HISTORIC AND DESIGN REVIEW COMMISSION

HDRC CASE NO: 2018-341
COMMON NAME: 416 KENDALL ST
LEGAL DESCRIPTION: NCB 1742 BLK 15 LOT S 50 FT OF 1 & 2
ZONING: IDZ H
CITY COUNCIL DIST.: 1
DISTRICT: Tobin Hill Historic District
APPLICANT: JMS Architects
OWNER: T.I.G.G. LLC
TYPE OF WORK: Construction of three, 3-story attached townhomes
APPLICATION RECEIVED: June 29, 2018
60-DAY REVIEW: August 31, 2018
REQUEST:

The applicant is requesting conceptual approval to construct three, 3-story attached townhomes in the vacant lot located at 416 Kendall St.

SHEET TITLE:
sitePLAN

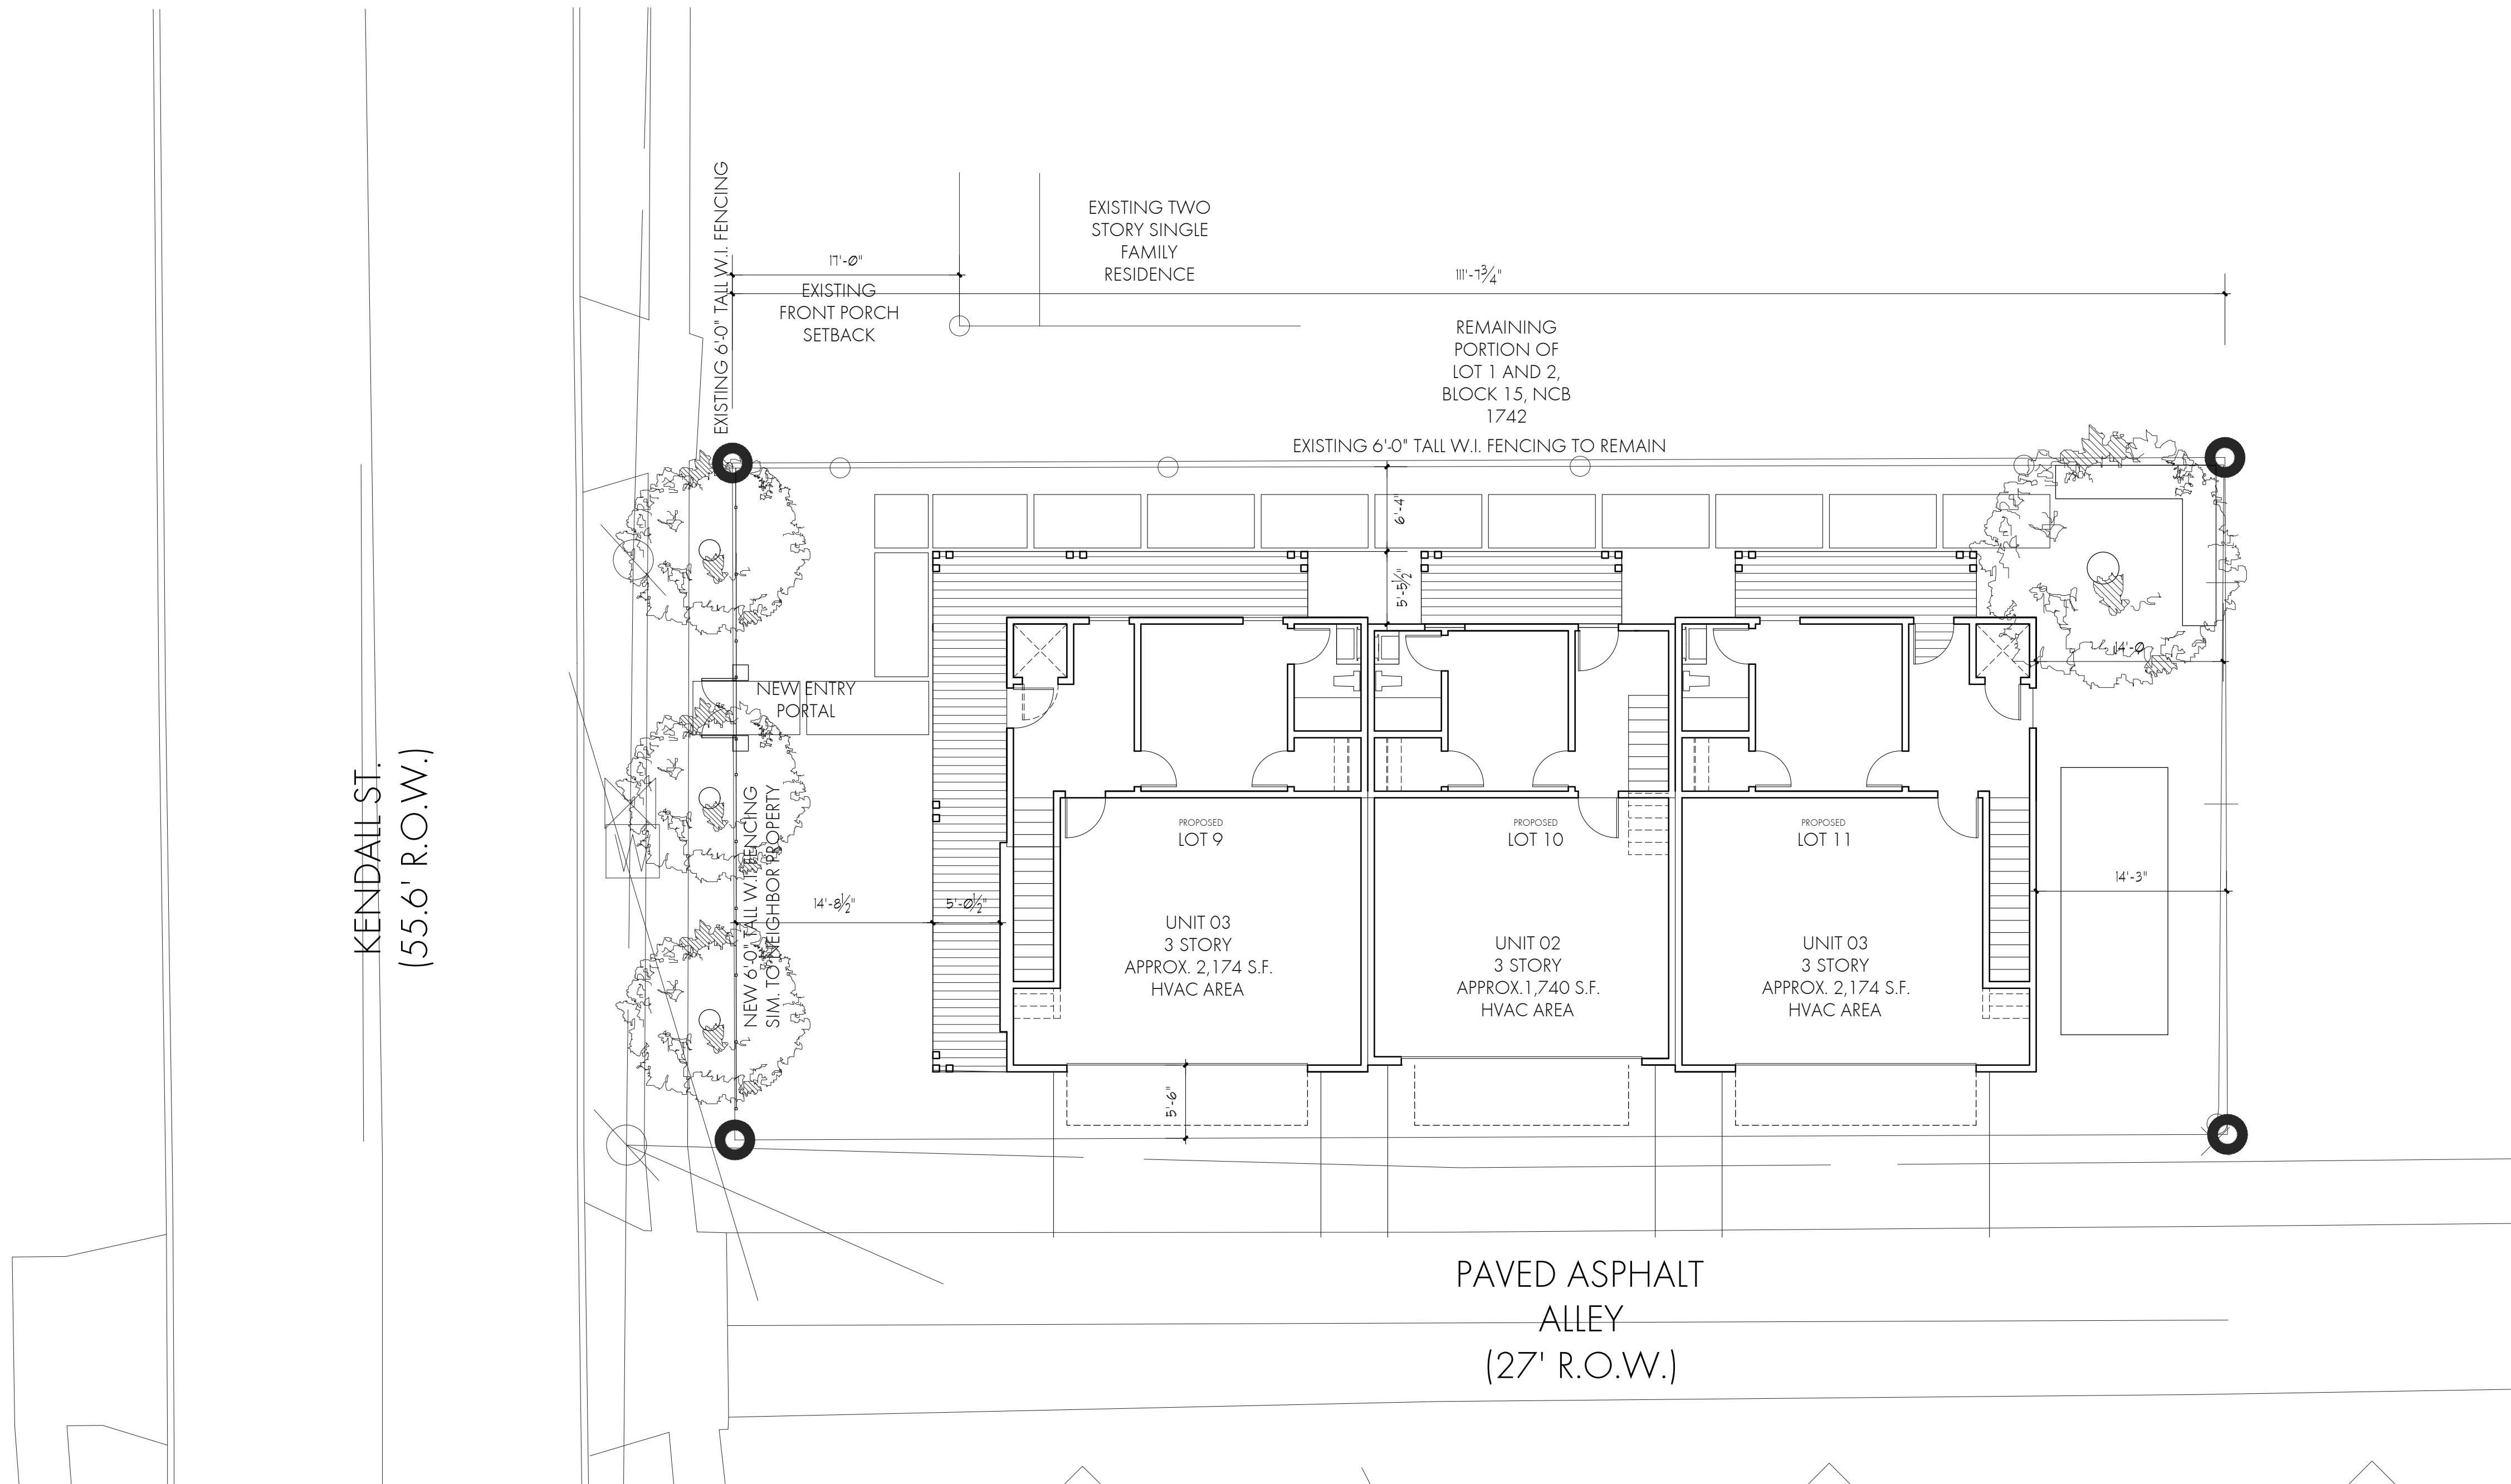
- d. SETBACKS – According to the Guidelines for New Construction, the front facades of new buildings are to align with front facades of adjacent buildings where a consistent setback has been established along the street frontage. The applicant has proposed a front setback of 12'-8" to the front porch. Based on the submitted site plans, this setback is slightly greater than the adjacent 2-1/2 story historic home, and greater than the adjacent 3-story church. Staff finds the proposed setback generally appropriate based on historic and existing context of the block.

- e. ORIENTATION & ENTRANCES – Based on the submitted narrative, the applicant has proposed for the front unit to face Kendall and for the two additional units to have front door access along the north side of the structure facing the existing 2-1/2 story historic house. The front unit will have a wraparound front porch to mimic porch precedents in the district. The historic development pattern of the block features two prevailing conditions: primary and accessory structures that face Kendall with driveways running along the side of primary structures to provide access to rear garages; and primary structures that face Kendall with rear accessory structures that front the alley to provide rear parking access. Based on the submitted historic aerial view of the site and Sanborn Maps, the historic structure that originally occupied the site featured a large primary structure similar in footprint to the adjacent structure to the north and a 1-story rear accessory structure fronting Kendall. The current project features three attached units containing rear-loading attached garages on the first floor, each of which are accessed from the alleyway to the south. According to the Guidelines for New Construction, the front façade should be oriented to be consistent with those historically found along the street frontage. Typically, historic entrances are oriented towards the primary street. Staff finds the front unit to be consistent with the Guidelines, but finds the orientation and entrances of the rear two units to be a departure from typical development patterns in the vicinity. Additionally, the provided site map indicates that a fixed window will face Kendall St on the first unit, with the true access on the north side of the structure. Several renderings show a front door facing Kendall St. Staff finds that the front unit facing Kendall should have an entry door facing the street. Staff does not find the orientation or entrances of the rear two units consistent with the Guidelines. Staff finds that a primary and secondary relationship would be more consistent with the Guidelines.

- q. DRIVEWAY – The applicant has proposed to install three new driveways fronting the unnamed alley. The material is proposed to be pervious grasscrete with grey gravel in the interstitial spaces. The driveways will be double wide to accommodate access to the three proposed 2-car garages. Staff does not find the proposed driveway and parking proposal consistent with development patterns in the district.

- r. HARDSCAPING – In addition to the proposed driveways, the applicant has also proposed a front walkway from Kendall St utilizing oversized concrete panels. The walkway will extend to the north to provide access to the rear two units. Staff finds the location and scale of the proposed walkway to be generally consistent, but as noted in previous findings, finds the overall orientation and entrances to be inconsistent with the Guidelines.

- ii. That the applicant proposes a primary and accessory structure condition to be more consistent with historic development patterns in the district as noted in findings o, f, and l.

- vi. That the applicant proposed a driveway and parking configuration that is more consistent with the Guidelines as noted in finding q.

SHEET TITLE:
ELEVATIONS
SHEET NO.

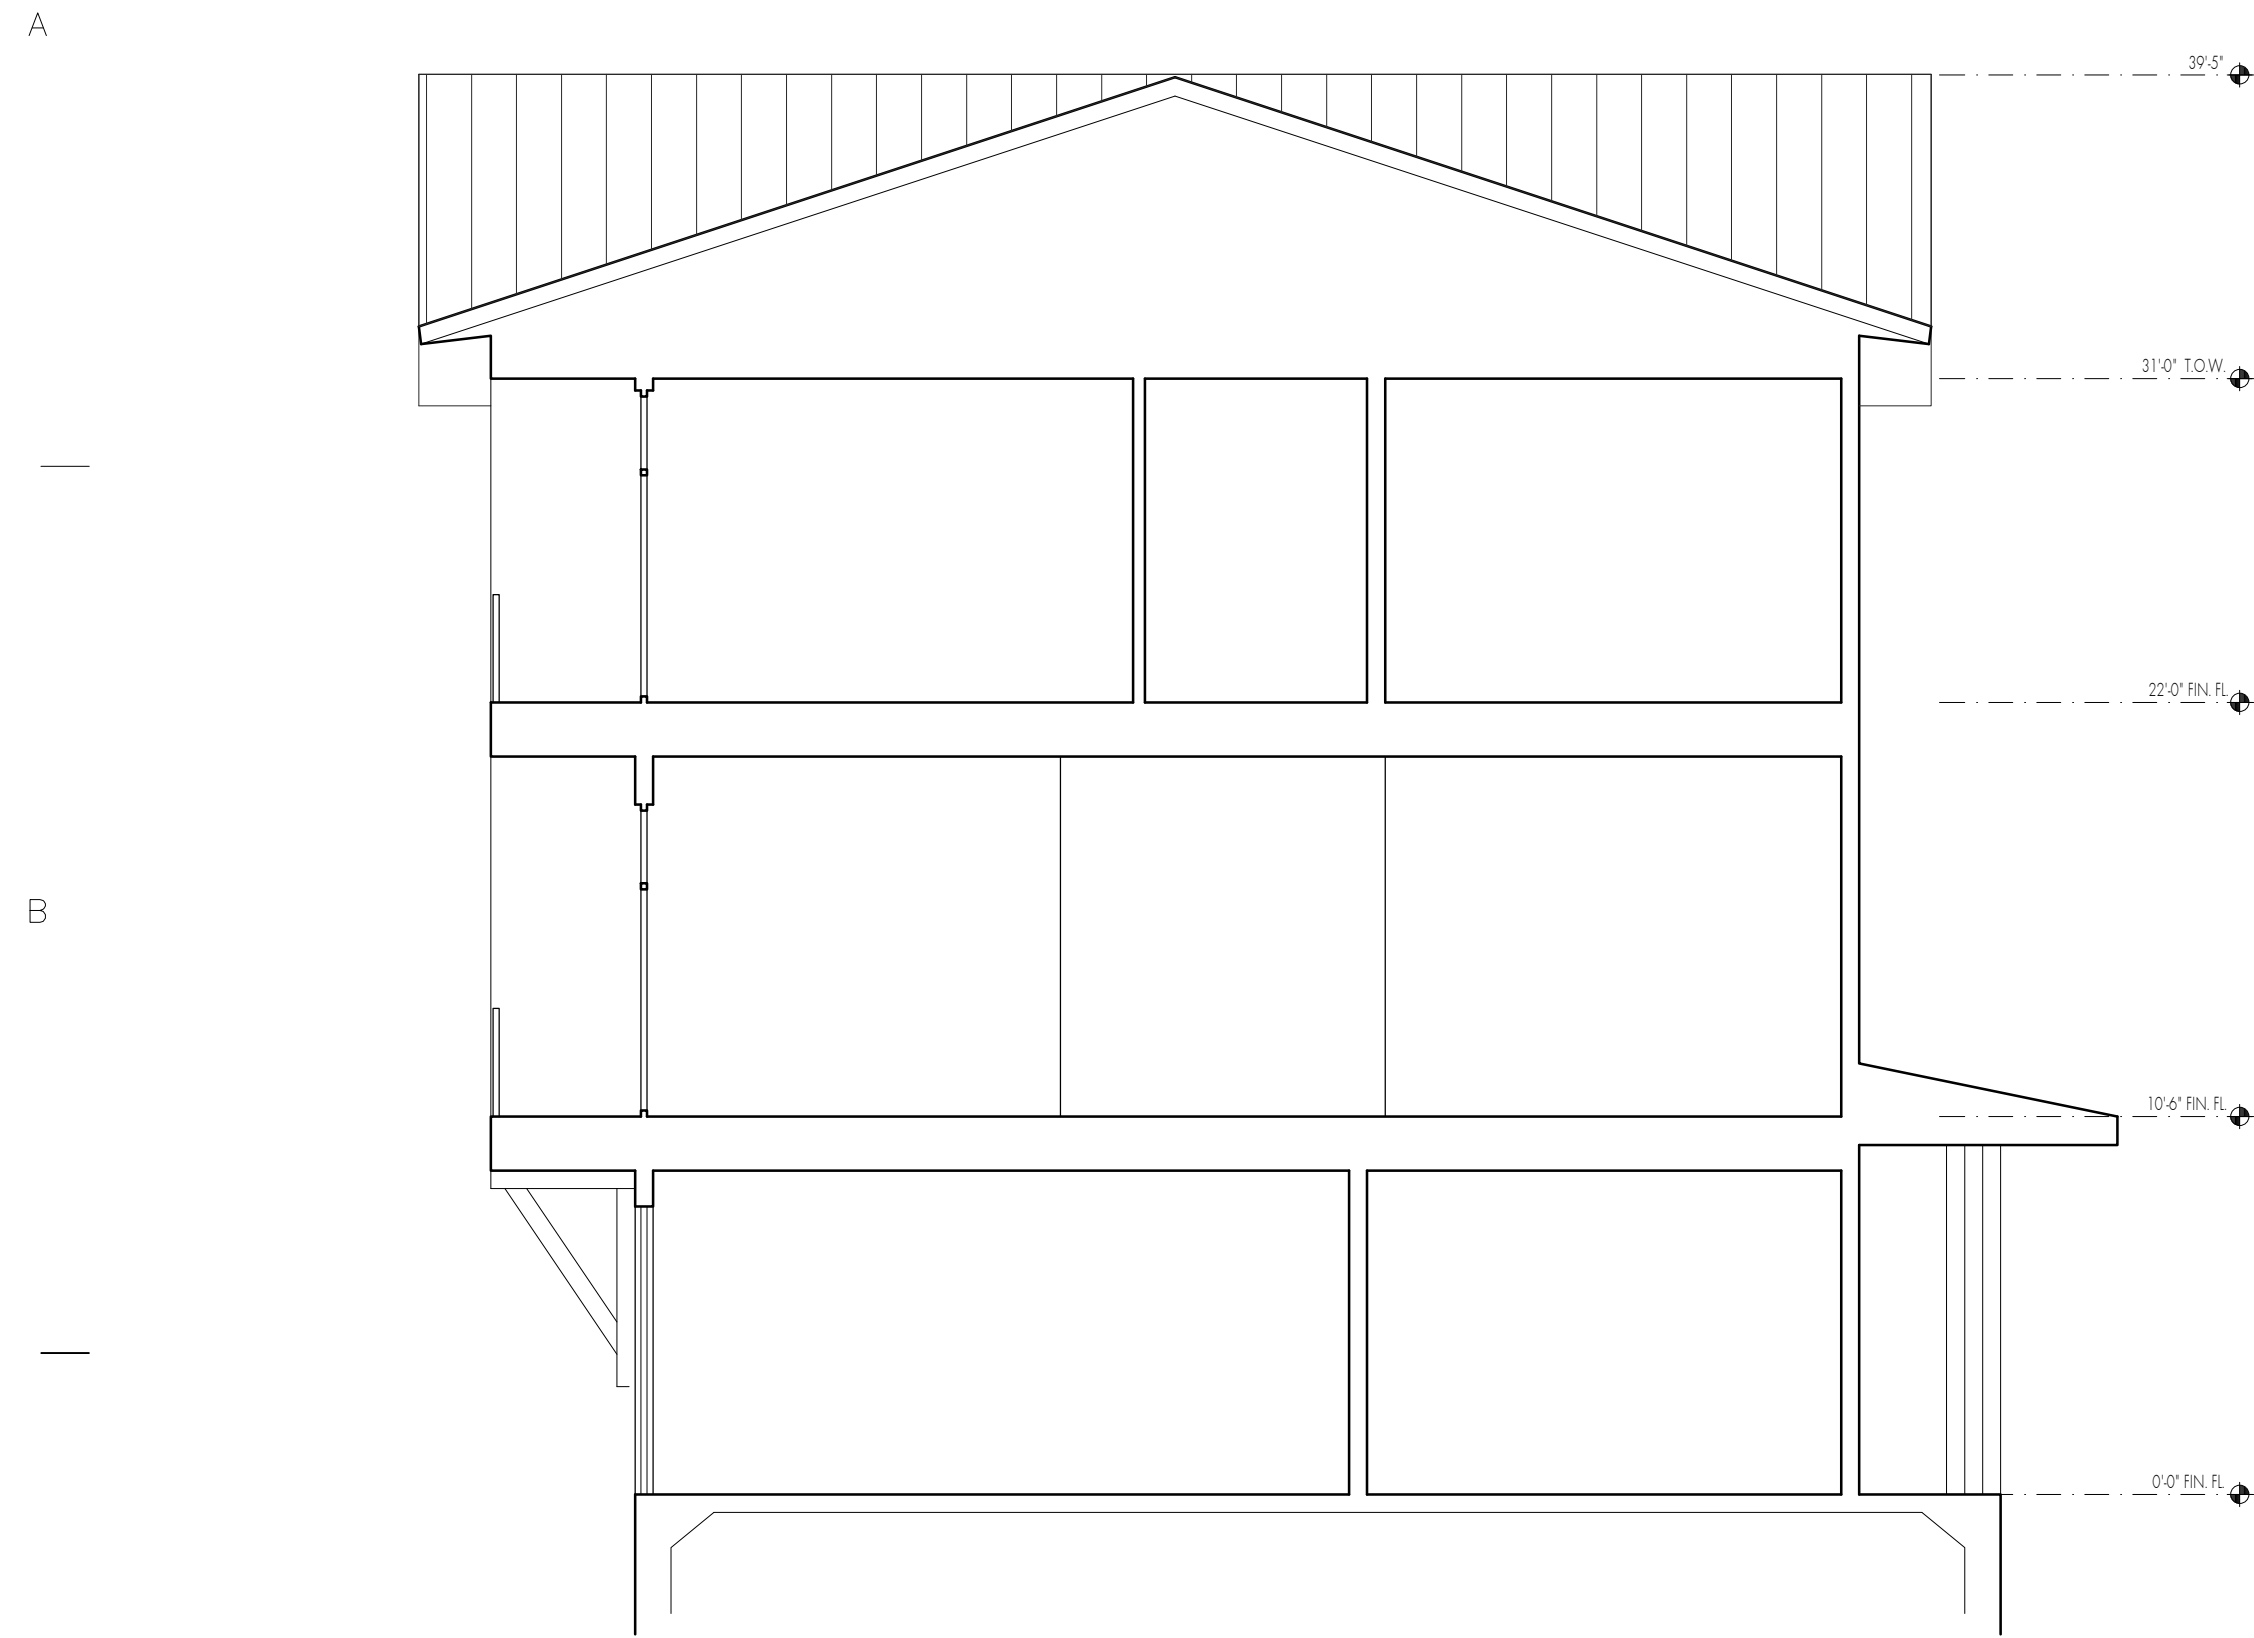
- f. SCALE & MASS – The applicant has proposed a 3-story structure containing three attached units. Per the submitted elevations, the ridge line of the structure measures 39'-5" from the ground. Guideline 2.A.i stipulates that the height and scale of new construction should be consistent with nearby historic buildings and should not exceed that of the majority of historic buildings by more than one-story. As noted in finding a, this block of Kendall features 1, 2, and 2-1/2 story historic structures and a 3-story church. The applicant has indicated that the proposed height is 5'-0" lower than the church to the south and within 10% of the adjacent 2-1/2 story structure to the north, which is indicated as having a height of 34'-4". The applicant has also provided the height for additional larger residential structures on Kendall, E Dewey Place, and E Myrtle, which include 43'-2", 38'-7", 34'-4", and 32'-3". While there are taller structures throughout the district, staff finds that 2-1/2 story structure would be more appropriate for the overall context of the block, which includes 1-story structures immediately to the east and west. Staff finds that the overall height should be lowered to be more consistent with the Guidelines.

- h. **ROOF FORM** – The applicant has proposed a sloped gable roof form. The front and rear units feature a side gable configuration with rafter tail detailing and the central unit features a low shed roof pitch. Staff finds that front and side gables are appropriate for the context of the district, but finds that the overall roof form is a departure from existing precedents based on its scale and configuration.

- i. **PORCH** – The applicant has proposed a 2-story, asymmetrical, wraparound front porch for the front unit. The porch will extend towards the street on the front façade and wrap around to the northern edge of the structure. The porch will feature a simple low sloped metal shed roof and a depth of approximately 2 feet. According to the Historic Design Guidelines, new construction should not attempt to mirror or replicate historic features, and new structures and design elements should not be so dissimilar as to distract from or diminish the historic interpretation of the district. The proposed porch pulls from traditional Craftsman-style language, as evidenced by the location and form, exposed rafter tails, square columns, and brick bases. The proposed columns are simple in design relative to historic Craftsman architecture and are a modern interpretation of the style. However, staff finds that the thickness of the proposed rafter tails should be reduced to be more consistent with traditional scale and proportions of these elements.

- n. **ARCHITECTURAL DETAILS** – New buildings should be designed to reflect their time while representing the historic context of the district. Additionally, architectural details should be complementary in nature and should not detract from nearby historic structures. Staff finds the modern interpretations of the Craftsman architectural style to be generally appropriate, but as noted in finding i, finds that the exposed rafter tail detailing should be minimized in scale.

- i. The applicant reduces the overall height of the structure to be more similar to 2 to 2-1/2 story precedents in the district as noted in finding f.

- iv. That the applicant reduces the scale and width of the proposed exposed rafter tail detailing as noted in findings i, m, and n.
- v. That the applicant proposed exterior materials that are more consistent with those found in the Tobin Hill Historic District and Craftsman residential structures as noted in findings m and n.
